Re: Stowe Parking Lot Improvements – Parking Lot A1, A2, A3 Expansion  
Site Plan Revisions

On behalf of VR US Holdings II, LLC, please find enclosed a revised set of the Stowe Mountain Parking Lot Improvements – A Lots Plans. As a follow-up to the 11/7/2023 DRB hearing, the plans have been revised to address feedback received both from Staff and the Board. These revisions include:

## Stowe Mountain Parking Lot Improvements - A Lots

**6 STAIR / BRIDGE 2 - ELEVATION**  
 A-100 SCALE: 1/8" = 1'-0"

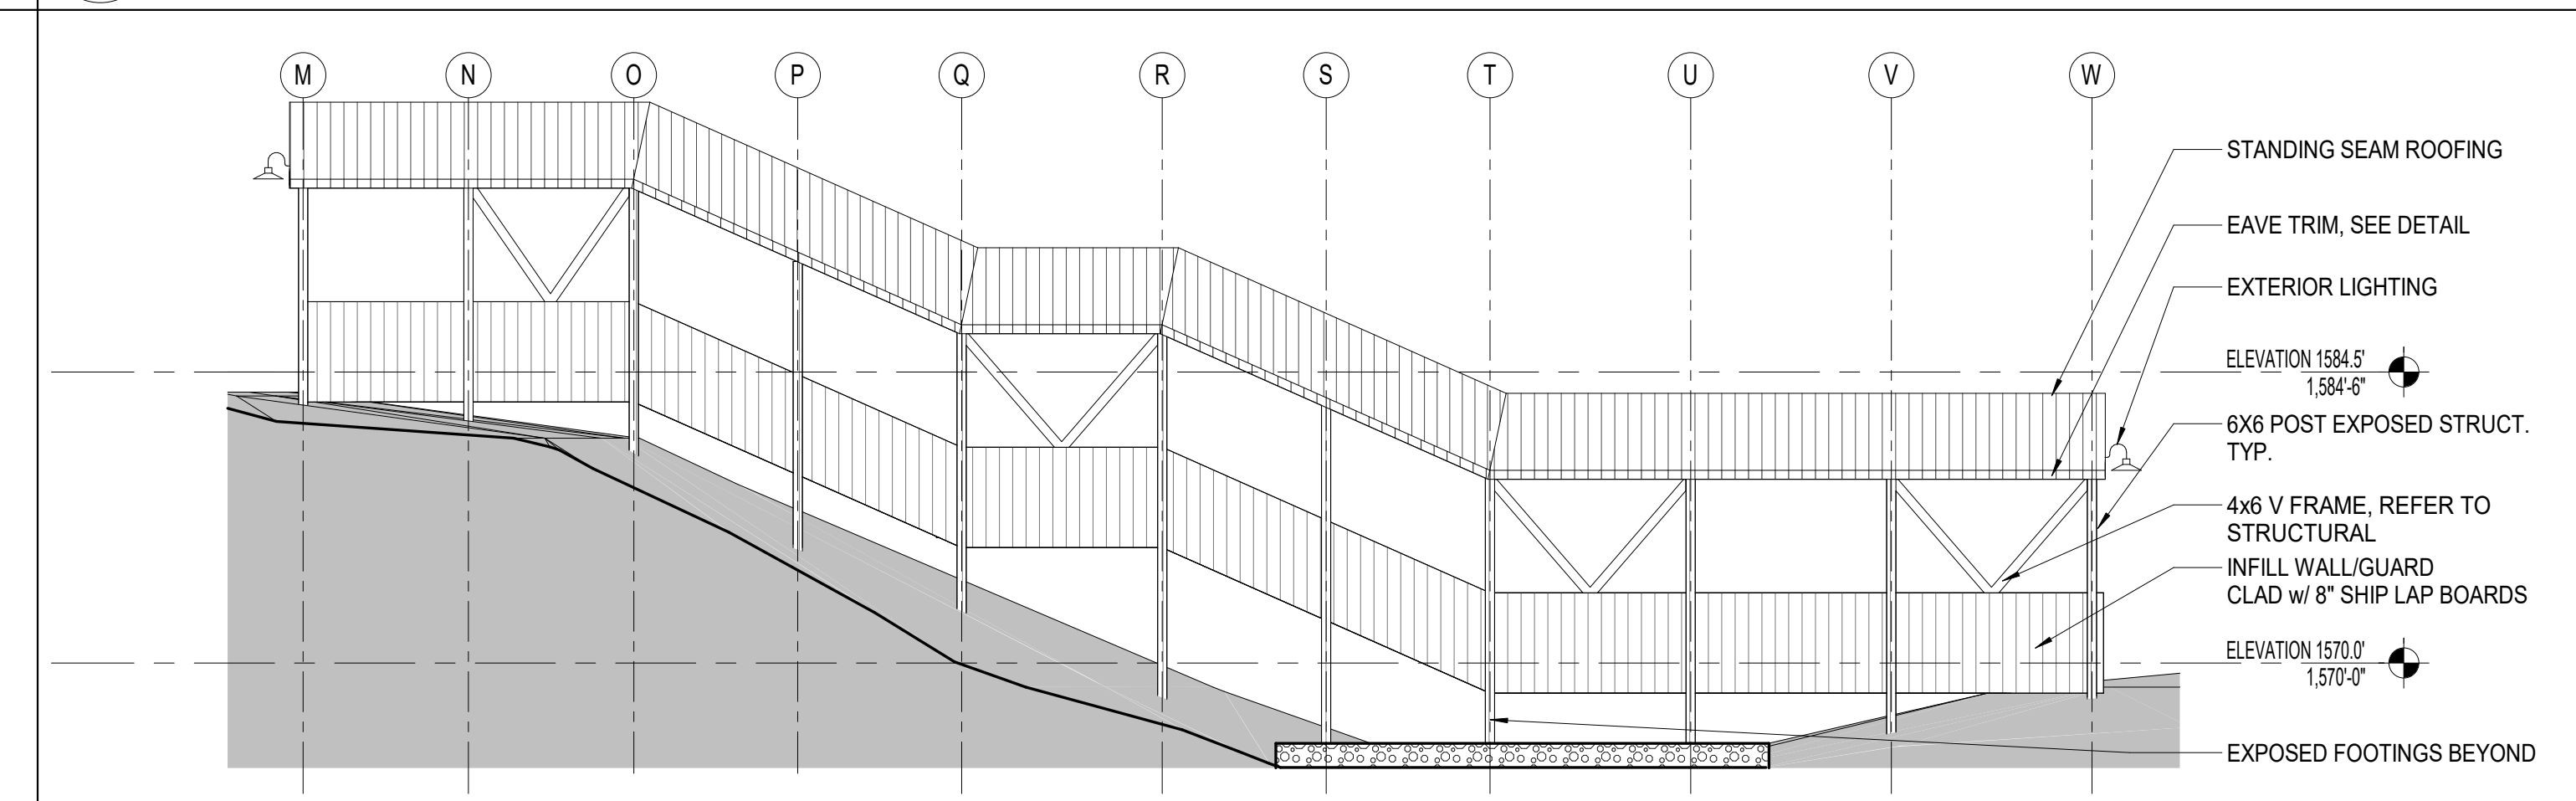
- 5) Revised Covered Stairway / Boardwalk Plans – The covered stairways and boardwalks have been revised to include recessed, ceiling mounted lighting as depicted on Sheet A-100 and A-500. In addition, exterior gooseneck lighting is proposed at each entrance / exit. Please refer to attached Parking Lot Stair Plan and light fixture cut sheets for additional information.
